Genesis Fashions Ltd.

126/1 Kadda Nandun, Kadda Bazar, Gazipur Sadar, Gazipur
(23.985952, 90.356677)

24th October 2015

Observations

Loose bolts

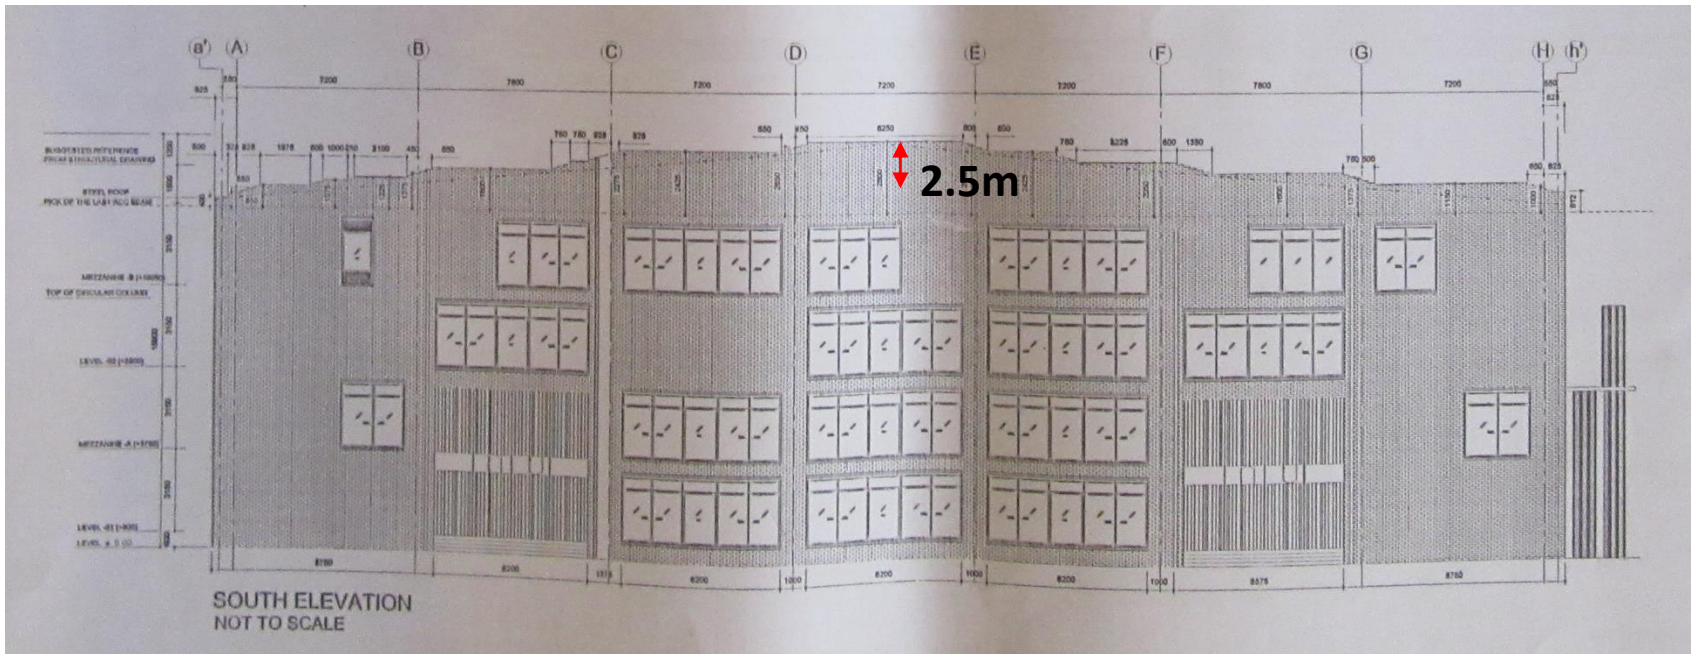
Bolted connections are found
loosened

ITEM 1: Loosened bolts needs to be tightened.
